Bent Grass East Commercial  
Filing No. 3  
Updated Traffic Impact Analysis  
PCD File No. SP2010  
(LSC #204660)  
May 17, 2021

# LSC Responses to EPC TIS Redline Comments

Map 14: 2040 Roadway Plan (Classification and Lanes)

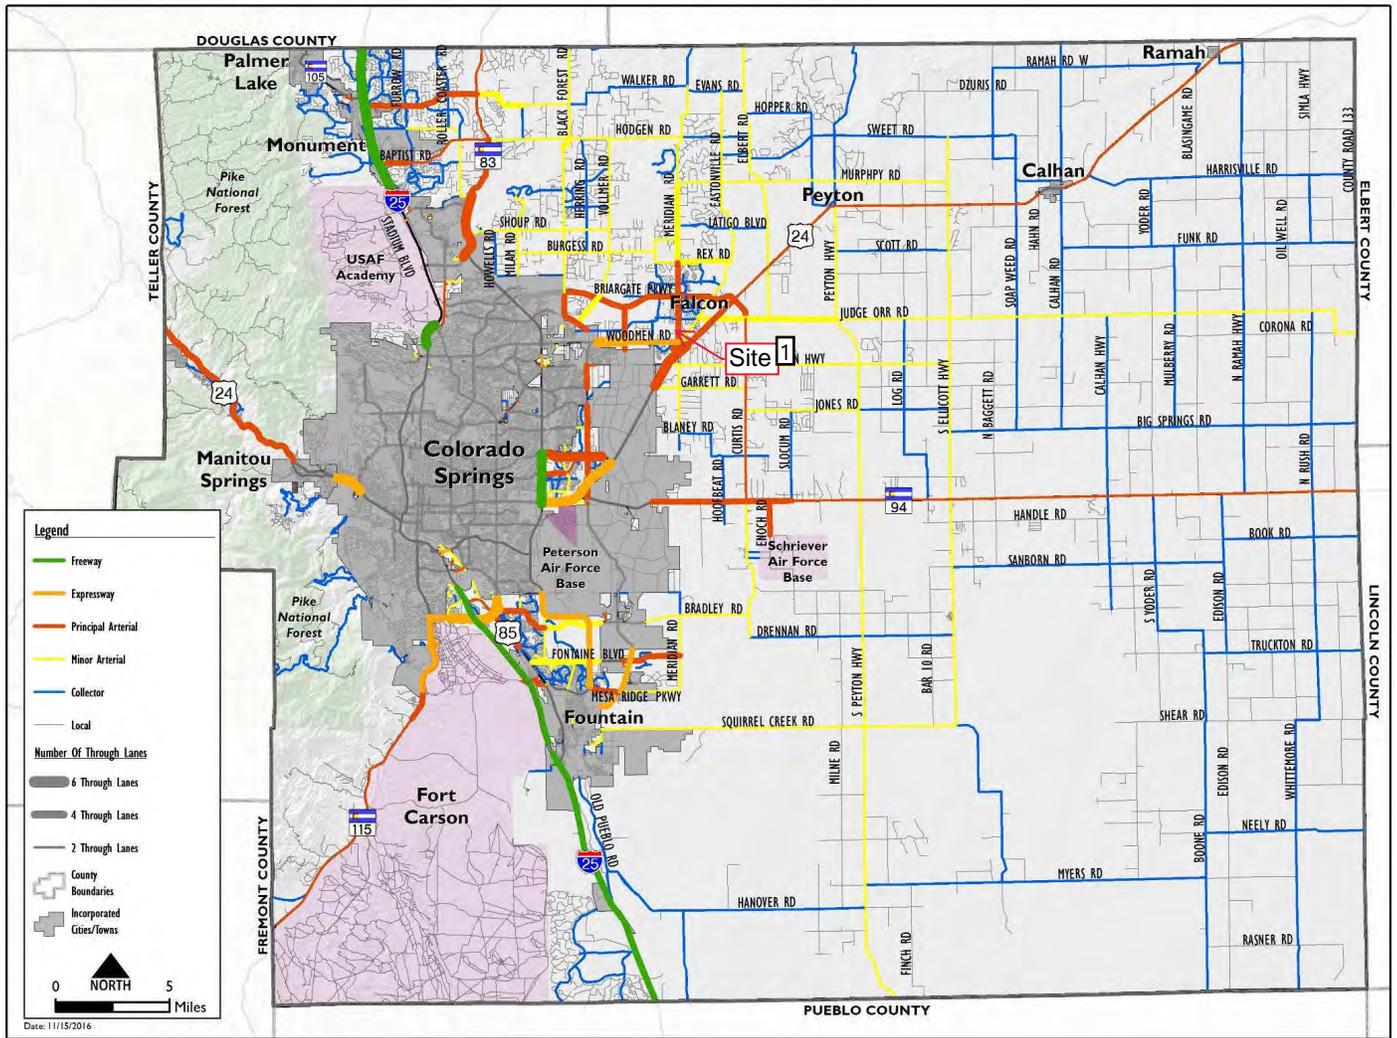
FYI: Prorata share contribution may be required toward final construction, paving and associated repairs to Bent Grass Meadows Drive southwest of the site, including design and construction of an eastbound left turn lane on Woodmen Frontage Road at Bent Grass Meadows Drive at the final plat stage should these improvements not be financially guaranteed or constructed by others. Conditions of approval are being drafted to that effect.

Author: jchodsdon Subject: Sticky Note Date: 8/19/2021 11:34:25 AM  
LSC Response: Comment Noted.
